Access Compliance Report

Public Rights-of-Way

(Curb Ramps)

Intersection ID: 24214	Main Street: HENSEY'S_WY	Cross Street: BEVERLY_CREST_BV	Location: SE
ADA ID: E0DA4760C084	Ramp Type: Perp	Initial Pass/Fail: Fail	Overall Compliance: No
Severity Score: 37.5			
Codes/Mitigation Info/Possible Solution		Field Measurements/Component Compliance

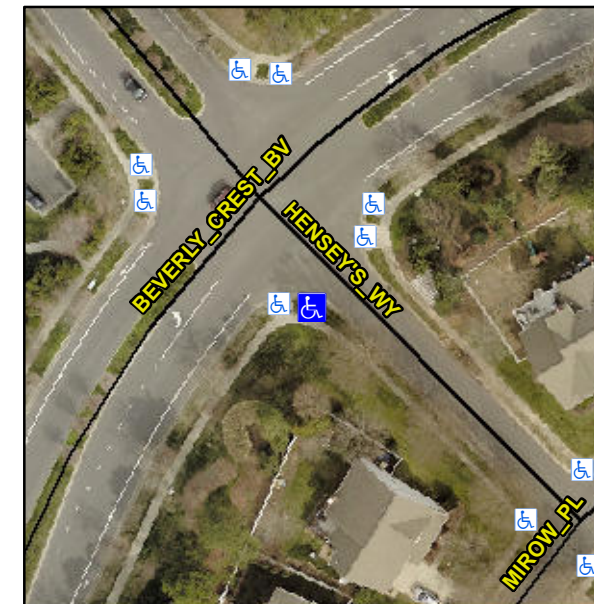
Not Found, R304.2.2, R304.5.3

Compliance	Description	Data	Compliance	Description	Data
N/A	Ramp Length (in)	99.0	No	Ramp Slope (%)	11.1
Yes	Ramp Width (in)	77.0	No	Ramp XSlope (%)	7.2
N/A	Flare Type LT	N/A	N/A	Flare Type RT	N/A
N/A	Flare Slope LT (%)	N/A	N/A	Flare Slope RT (%)	N/A
N/A	Flare Traversable LT?	N/A	N/A	Flare Traversable RT?	N/A
N/A	Landing Length (in)	N/A	N/A	DWS Provided?	N/A
N/A	Landing Width (in)	N/A	N/A	DWS Contrast?	N/A
N/A	Landing Slope (%)	N/A	N/A	DWS Length (in)	N/A
N/A	Landing X Slope (%)	N/A	N/A	DWS Full Width?	N/A
N/A	Landing Curb? (Y/N)	N/A	N/A	DWS Offset (in)	N/A
N/A	Shared Landing?	N/A			
N/A	Gutter Ponding?	N/A	N/A	Gutter Slope (%)	N/A
N/A	Gutter Lip Ht (in)	N/A	N/A	Gutter X Slope (%)	N/A
N/A	Painted X Walk1?	No	N/A	Painted X Walk2?	N/A
	X Walk 1 Direction	To NE		X Walk 2 Direction	N/A
N/A	X Walk 1 Width (in)	N/A	N/A	X Walk 2 Width (in)	N/A
	X Walk 1 Slope (%)	3.1		X Walk 2 Slope (%)	N/A
	X Walk 1 X Slope (%)	8.8		X Walk 2 X Slope (%)	N/A

Remove & Replace Entire Ramp.
